**DAVIS CANYON
DATA REVIEW AND COMMENTS**

APRIL 1986

HIGH LEVEL NUCLEAR WASTE OFFICE

Figure 1. Well locations nearest Davis Canyon site. Modified from DEA.

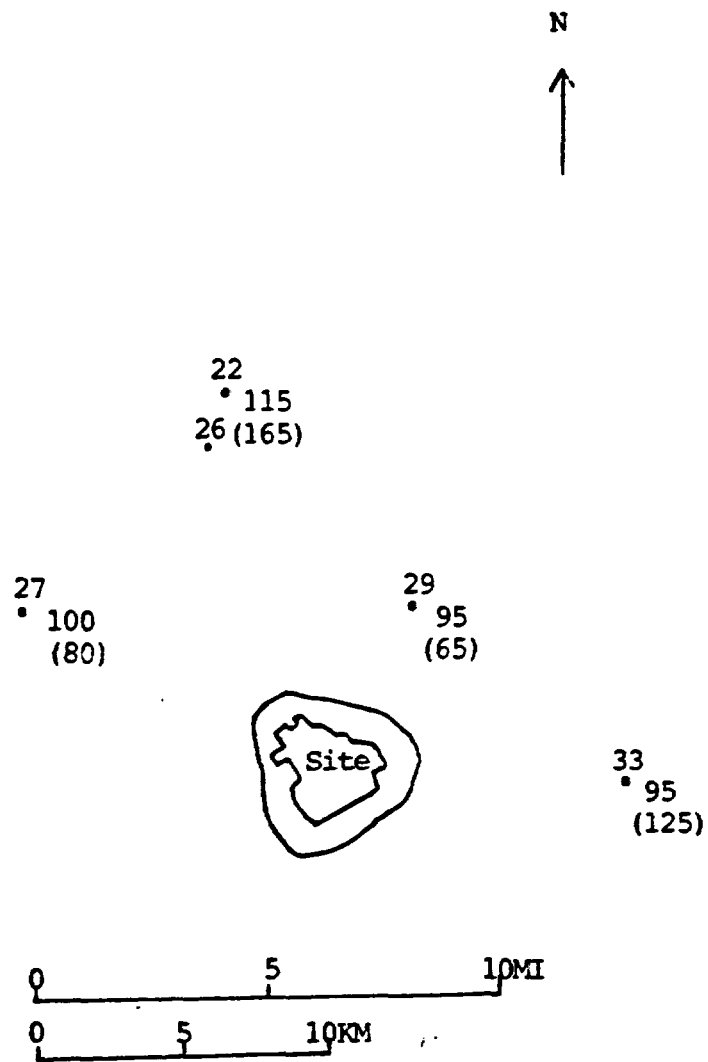
5) Well log data alone are inadequate for characterizing stratigraphic changes in the area. There are few wells which intersect Salt Cycle 6 in the immediate site vicinity. Figure 1 shows the location and DEA designation of

these wells and the repository location. Due to the limited amount of data and the large distances between data points (about 5 miles), a large degree of uncertainty exists in the stratigraphic projections.

Discussions with DOE confirmed that the carnallite zone can be identified with radioactivity logs and can be correlated from well to well. The following is a list of carnallite thicknesses in the wells closest to the site and the thickness of the salt underlying the carnallite. These values are shown in Figure 1.

A conservative assessment of the data would assume that carnallite will occur in the repository area. If only the non-carnallite zone of Salt Cycle 6 below the carnallite is considered as the repository host horizon, then the repository horizon thickness would be predicted to be about 95 feet. This estimate is below the minimum adequate thickness of 100 feet stated in the Davis Canyon DEA.

Figure 2. Elevation of top of salt. From Kitcho et al., 1984.

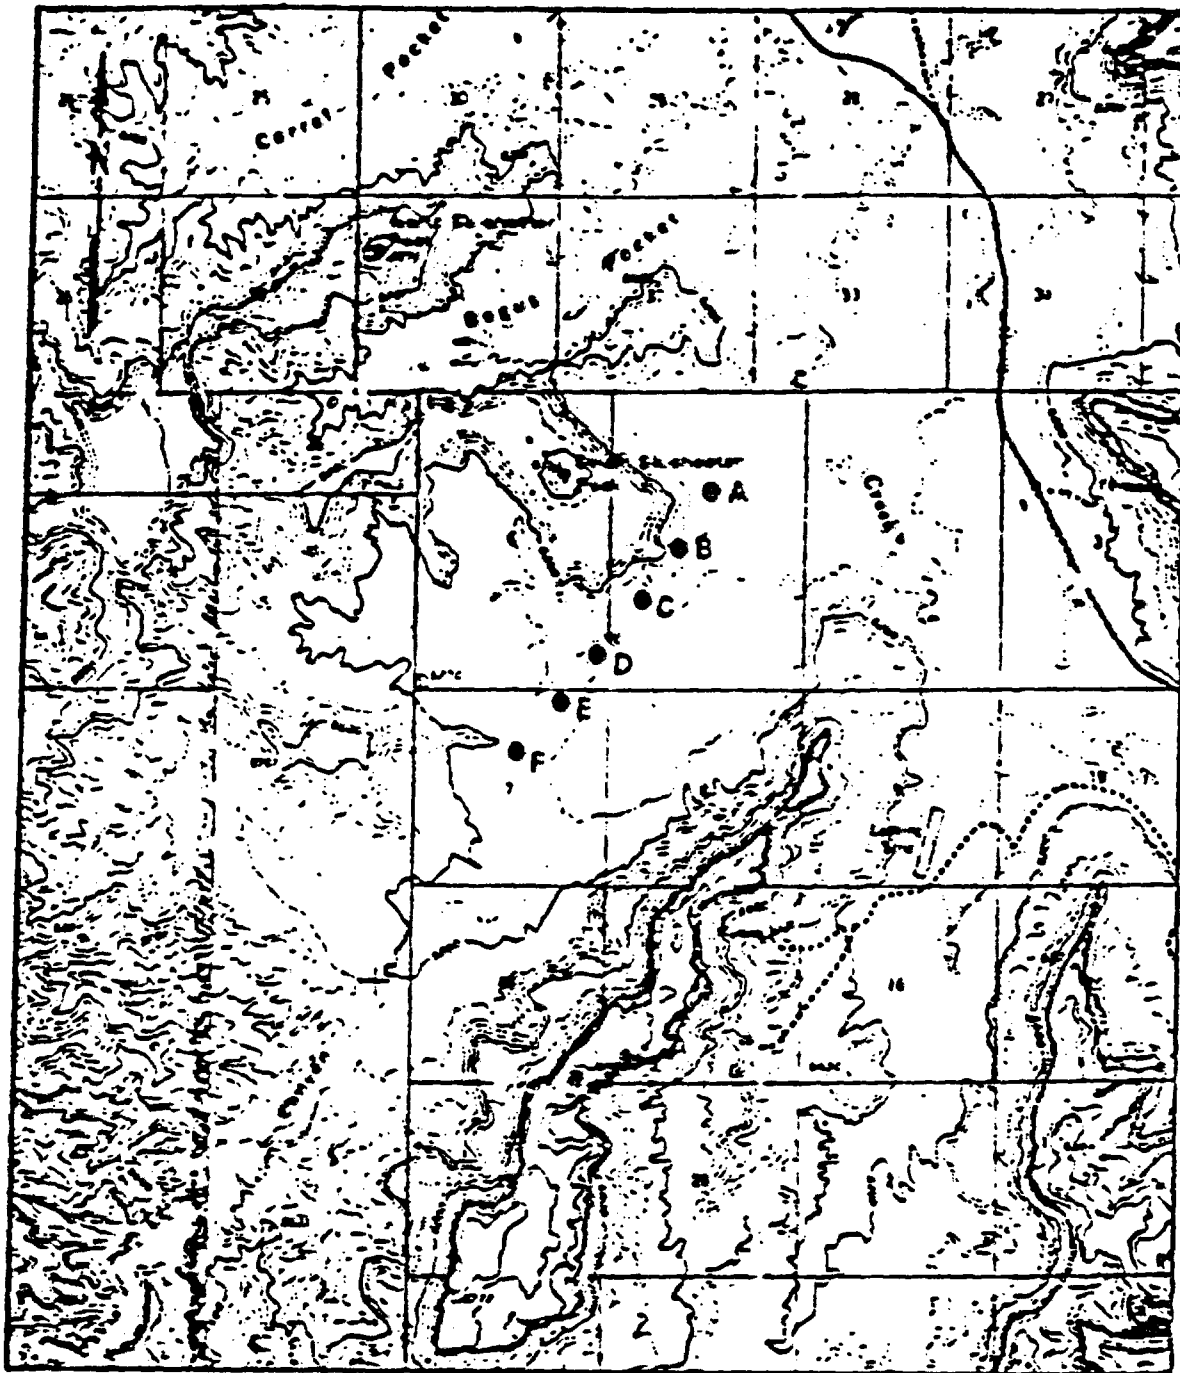
3) The State of Utah's detailed examination of aspects of seismic lines 33 and 37 indicated that the vertical extent of several faults could be interpreted to be higher than that indicated by DOE contractors. The proposed theory that faulting in the area of the proposed site ceased during early Paradox time has not been conclusively demonstrated and has not been uniformly applied in other DOE interpretations. Younger faults have been interpreted by the DOE to be the result of collapse caused by dissolution. Contradicting this view is the Lockhart Basin area interpretation in Figure 5-3 of McCleary (1983). This figure shows possible faults cutting the Paradox Formation-Honaker Trail Formation contact.

4) The data permit the interpretation of faults in places where DOE contractors interpreted marked stratigraphic changes. On line 37, reflectors were noted to be offset from below the top of the Mississippian reflector to the near surface. Offset reflectors are generally an indication of a fault. If this is a fault, then it is within the repository area at about the same location as DOE Fault EEE, which is shown to intersect only the Precambrian reflector. The orientation of the newly identified possible fault is unknown but it appears to intersect seismic line 37 at an oblique angle. The offset is down to the northeast. Information in Figure 6-1 and Table 6-1 in Kitcho et al. (1984) confirms the existence of structural changes at the top of the Paradox Salt in this area. Figure 2 shows the elevation of the top of salt in Davis Canyon using the information from Table 6-1. An increase is noted in steepness of the dip in the area between shot points C and D. The fault which the State of Utah believes may be inferred is in this same location and has the same sense of offset.

Figure 3. Reflection times on top of Mississippian reflector. From Kitcho et al., 1984.

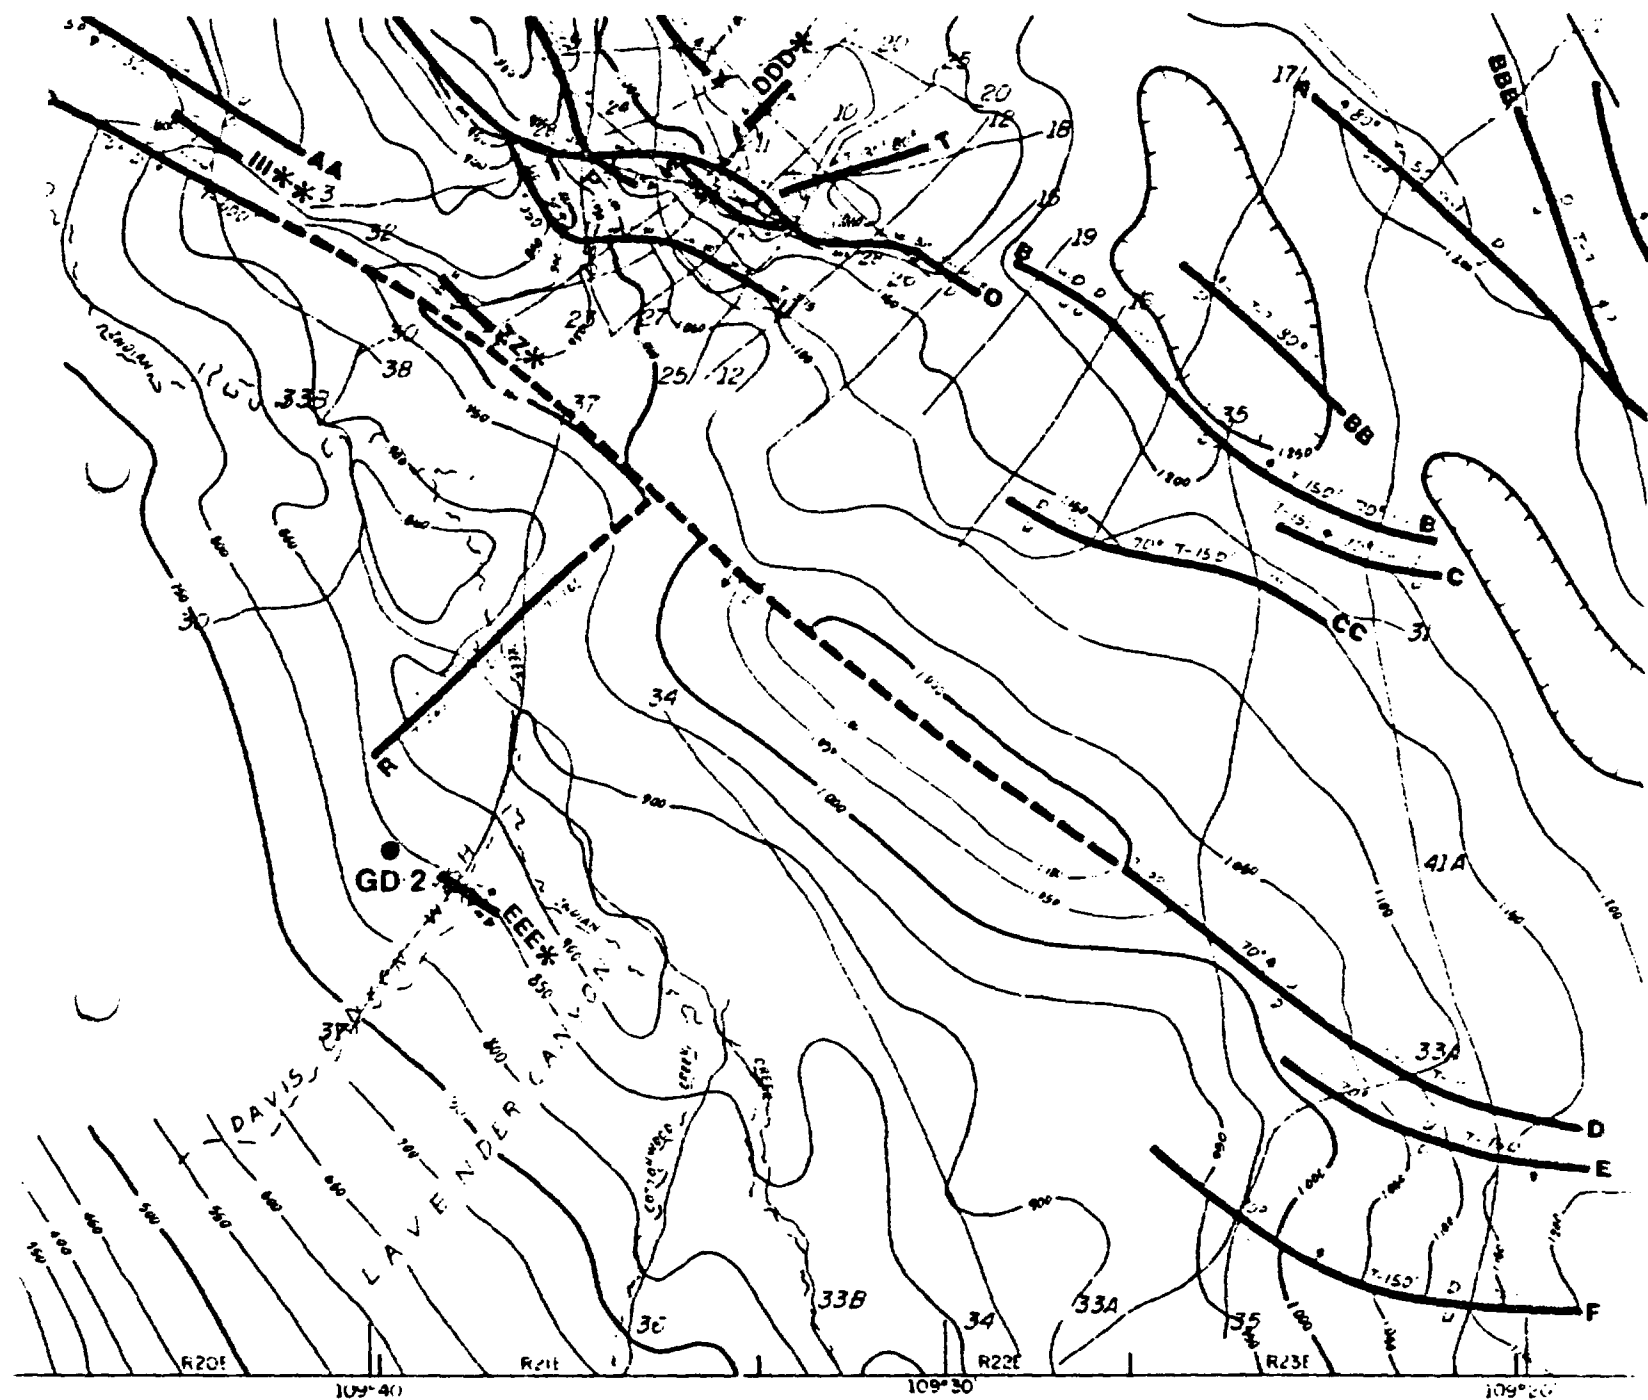
On Figure 5-3 of Kitcho et al. (1984), the contouring around the central part of Fault D is not supported by the seismic data (see Figure 3.). It indicates a greater amount of offset in the central area of the fault, where there are no data, than in the areas where there are data. The contouring also juxtaposes a closed structural low and a closed structural high across a fault. Standard contouring procedures take into consideration the relationship between features on opposite sides of faults.

After some discussion at the Denver meeting about whether the existing contouring was merely a different but justifiable interpretation of the data, it was recognized that the interpretation was more complicated than indicated by the data. DOE contractors stated that this type of "optimistic" contouring is the norm in the petroleum industry: If the data do not disallow it, an

interpretation which suggests potential drilling targets is used. DOE contractors agreed that this area should be recontoured to better represent the data.

The contouring at the south end of Fault R reflects unwarranted certainty about existing conditions (refer to Figure 3). The reflection time contours south and west of Fault R are drawn continuously. The contours are not dashed or question marked as is standard practice when no data exists. Drawing the contours continuously conveys to the reader a certainty that Fault R does not continue to the southwest. In fact, reflection data indicate that the offset on Fault R, is increasing to the south, so it is probable that Fault R does continue to the southwest. With the knowledge that the offset is increasing southwestward, a more accurate map would show a dashed continuation of the fault and dashed reflection time contours south of the fault.

Figure 4. Possible revised contouring of reflection times on top of Mississippian reflector. Modified from Kitcho et al., 1984.

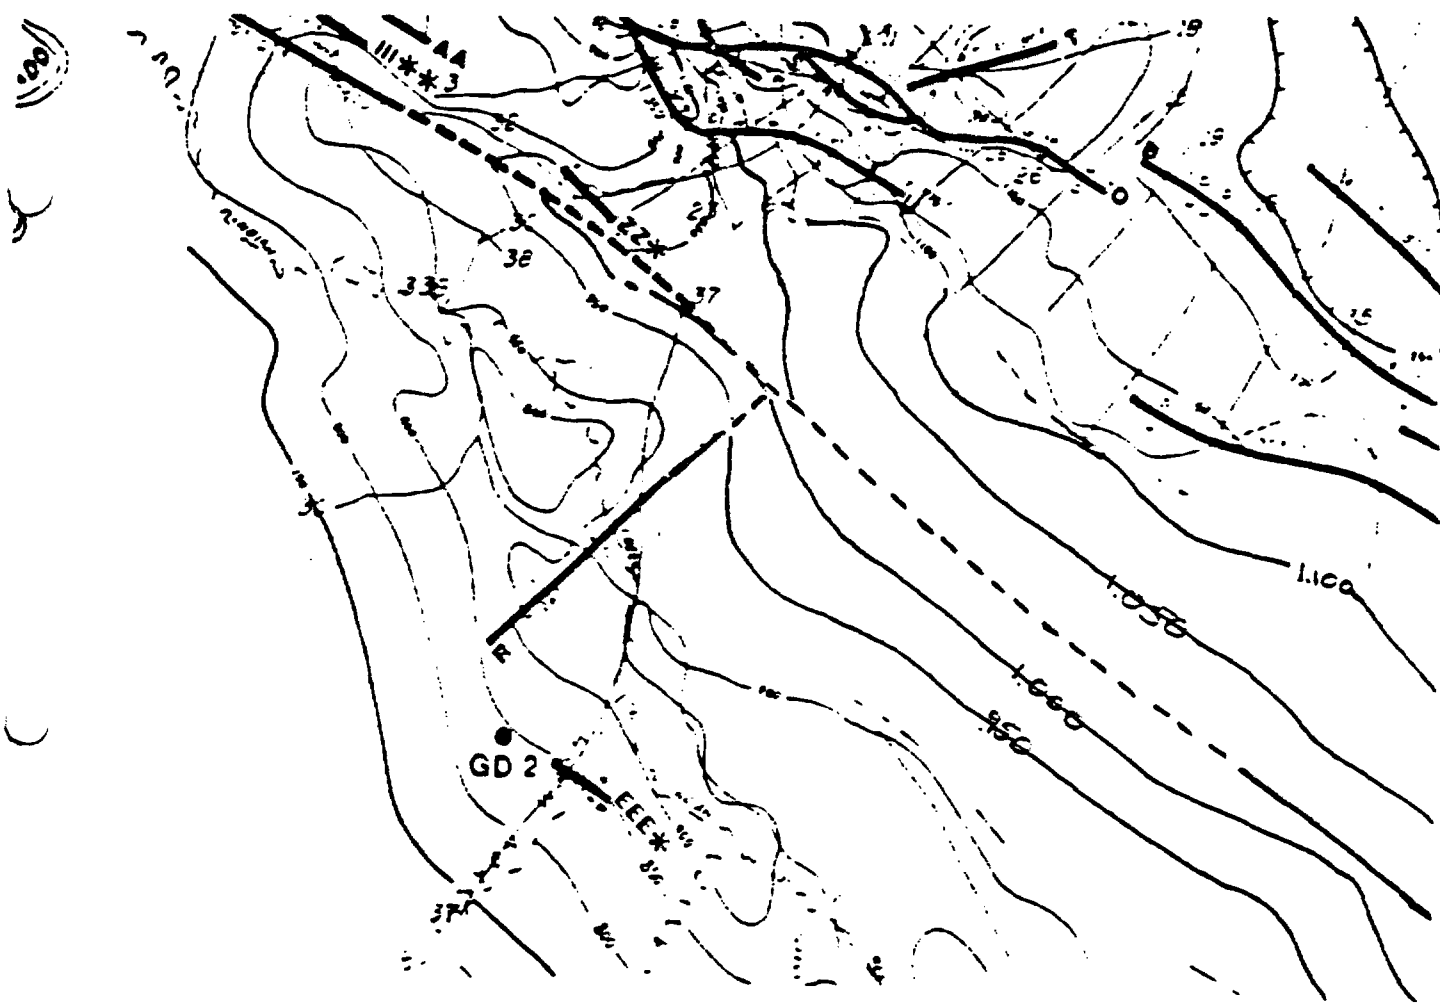
A possible alternate contouring approach is shown in Figure 4. This approach reduces the offset across fault D. It also eliminates the appearance that the north end of Fault R has a different sense of offset (south side up) than the south end of Fault R. This is a better approach because the data do not indicate such an offset change.

Figure 5. Lockhart Basin faulting. From Kitcho et al., 1984.

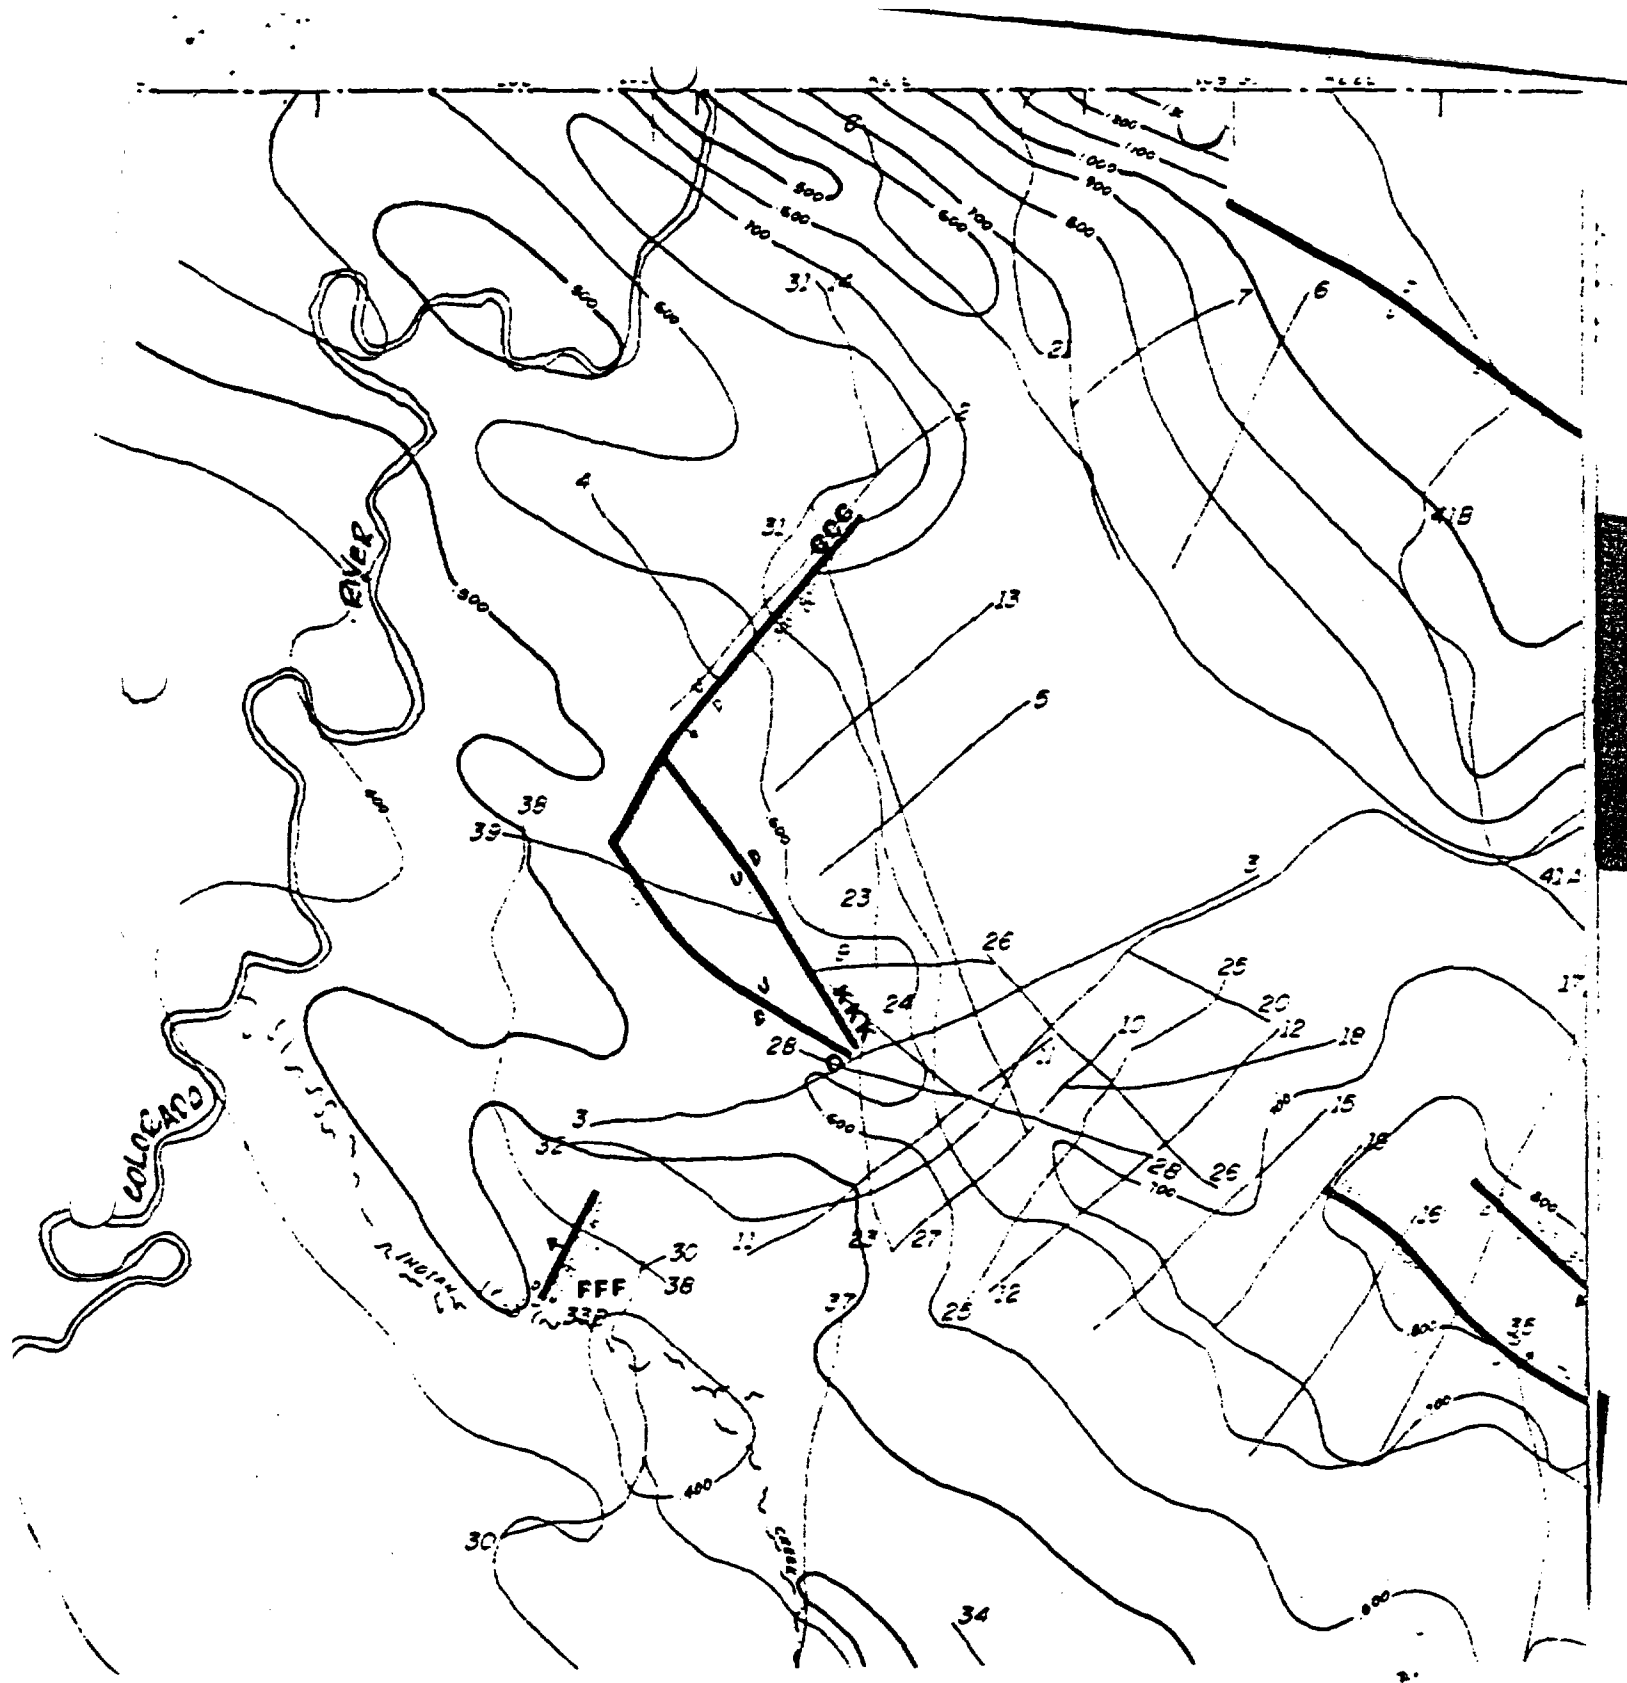
In the Lockhart Basin area, Faults KKK and O show offsets that would produce a horst in the Paradox Formation (Figure 5). McCleary (1984) shows cross-sections showing a graben in the Paradox consistent with dissolution and collapse. Seismic line 39, which crosses Fault O, was reviewed and found to be of very poor quality; it could not, therefore, support the indicated interpretation. Consequently, it was agreed to dash the faults and change the sense of offset on both Faults O and KKK.
